Application No. 09/880,649

Amendment and Response Under 37 CFR 1.312 dated September 14, 2004

Reply to Notice of Allowance dated July 28, 2004

**Amendments to the Drawings:**

### FIG. 3

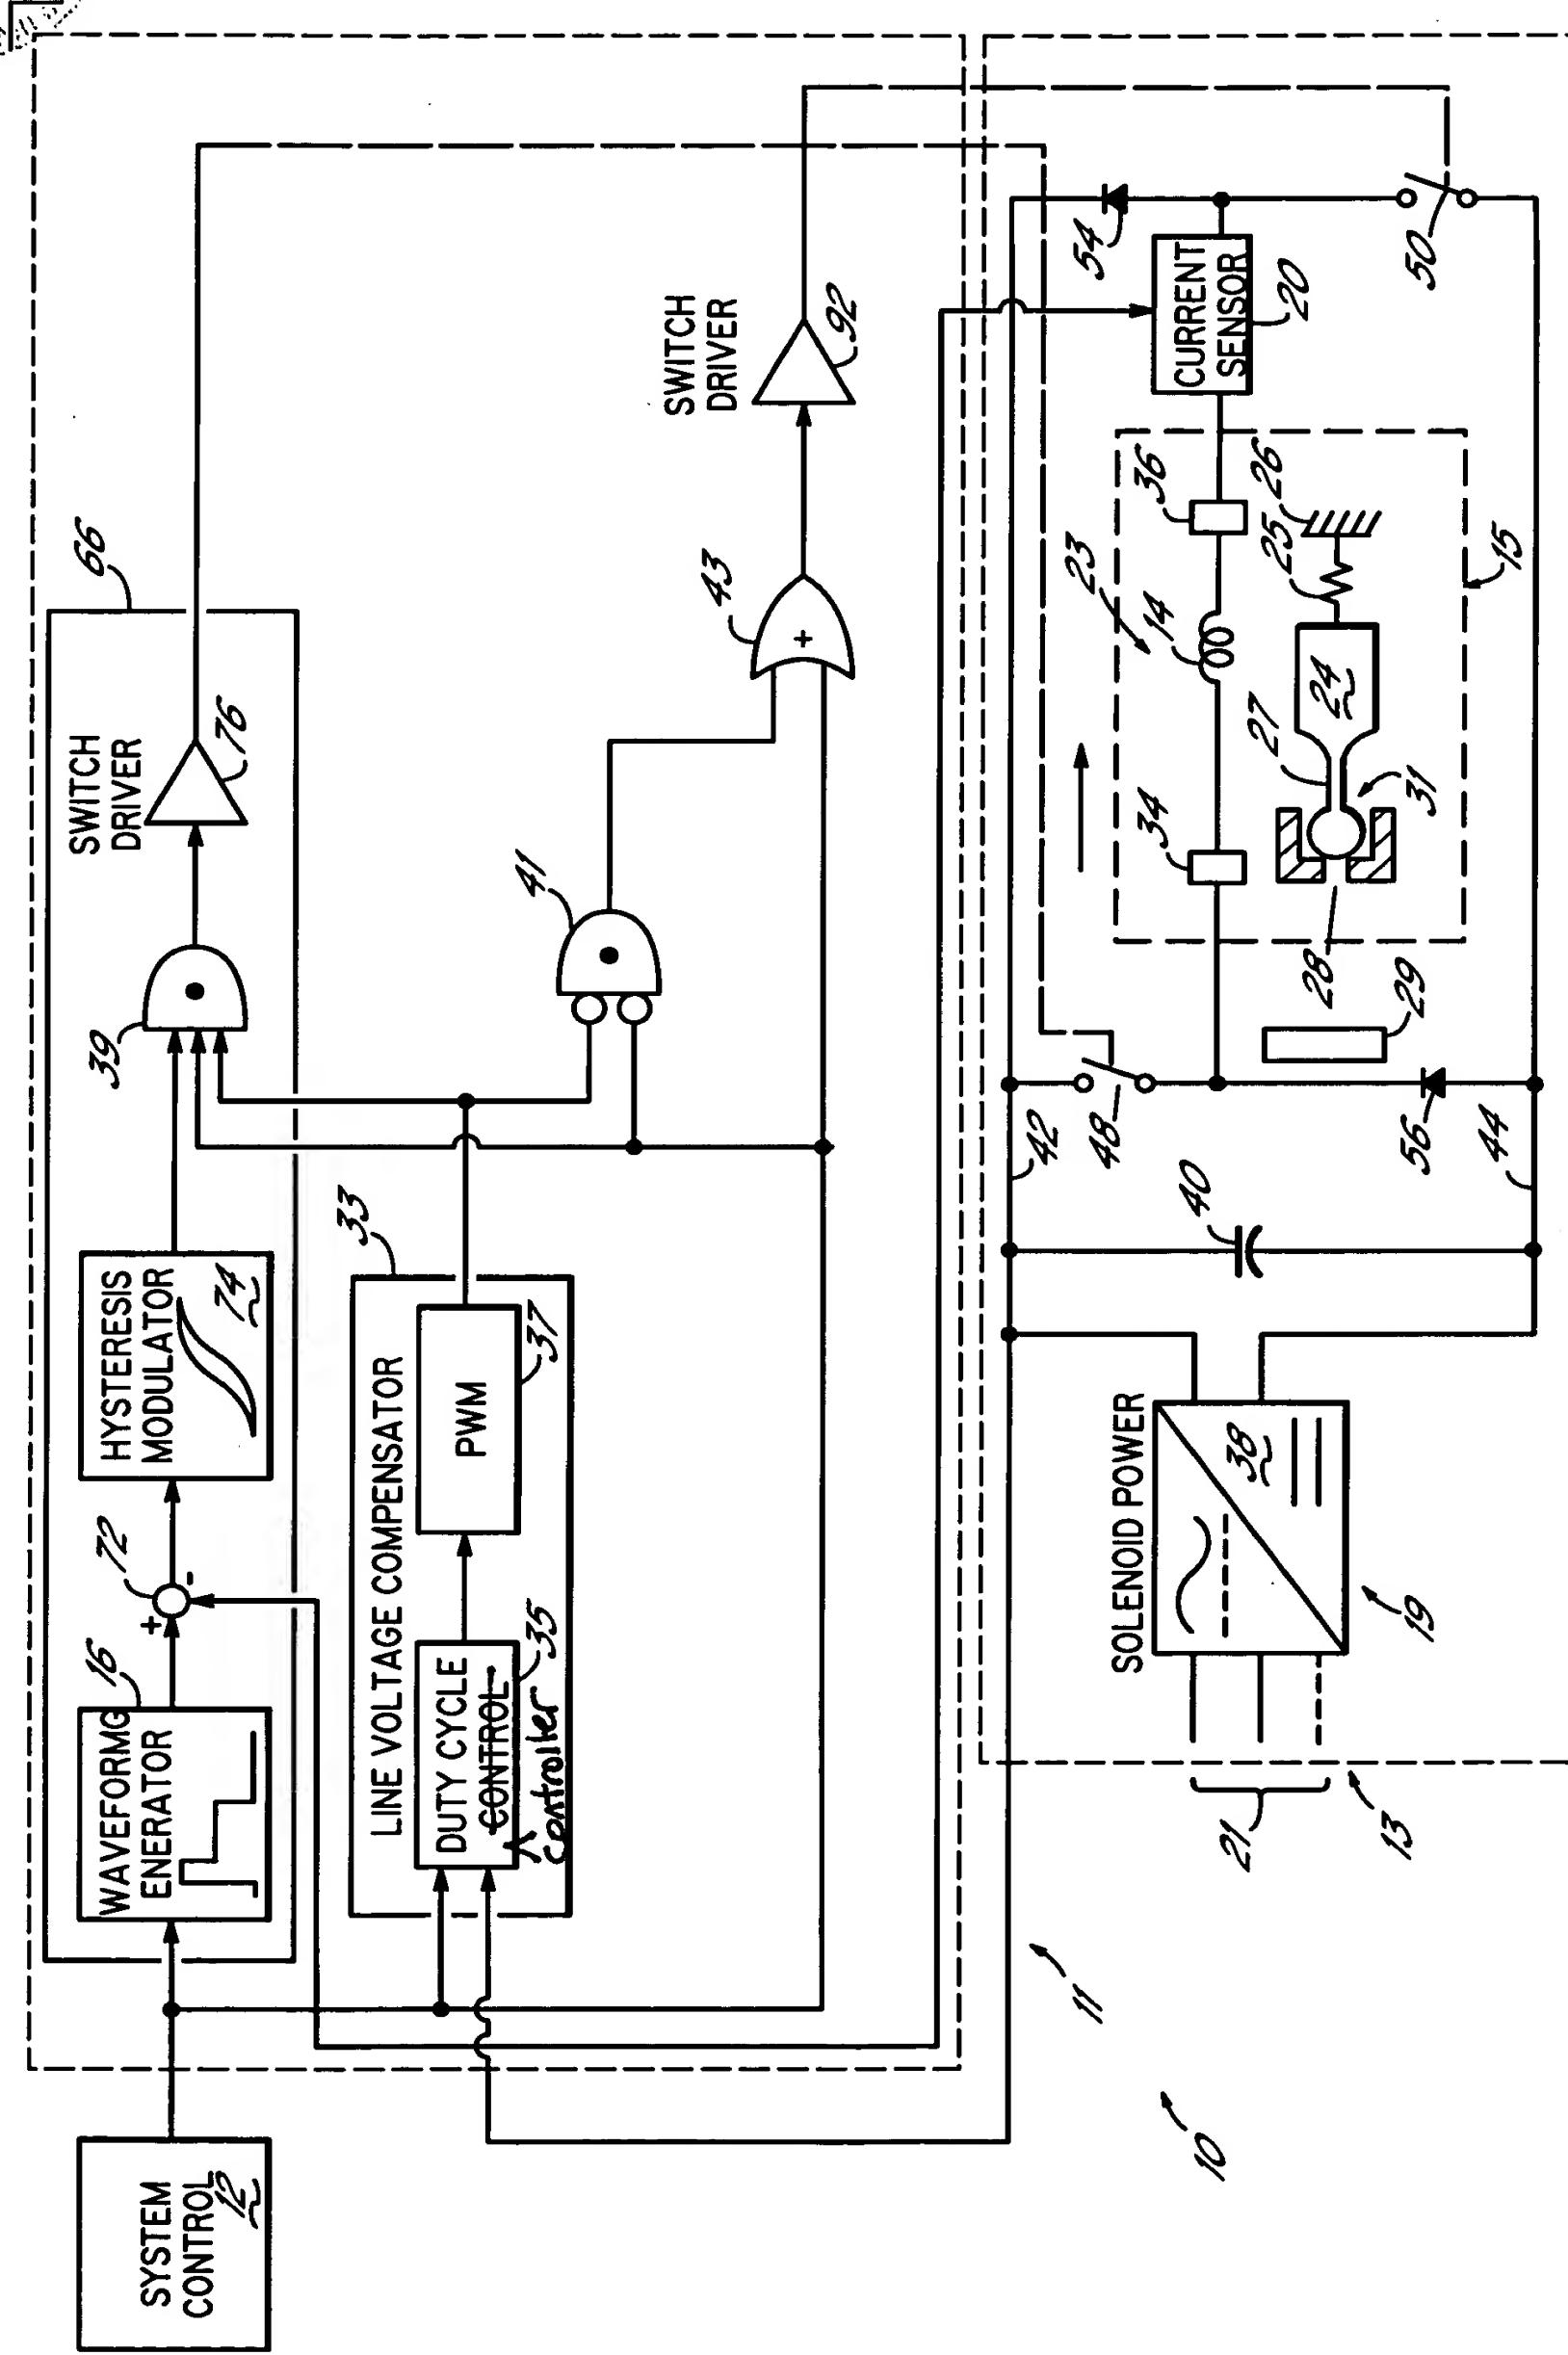
The attached sheet of drawings includes changes to Fig. 3. This sheet, which includes Fig. 3, replaces the original sheet including Fig. 3. Applicant is changing the label of element 35 of Fig. 3 to "duty cycle controller"

Claim 20 is directed to the embodiment of Fig. 3; and in reviewing claim 20, it was discovered that power switch control is incorrectly recited. With respect to Fig. 3, the power switch control comprises the waveform generator 16, summing node 72 and hysteresis modulator 74. However, the duty cycle controller 35, PWM 37 and first logic circuit 39, 76 are part of the duty cycle control recited in claim 1. The confusion arises because a common label "duty cycle control" is applied to element 22 of Fig. 1 and element 35 of Fig. 3. To eliminate the confusion, Applicant is changing the label of element 35 of Fig. 3 to "duty cycle controller".
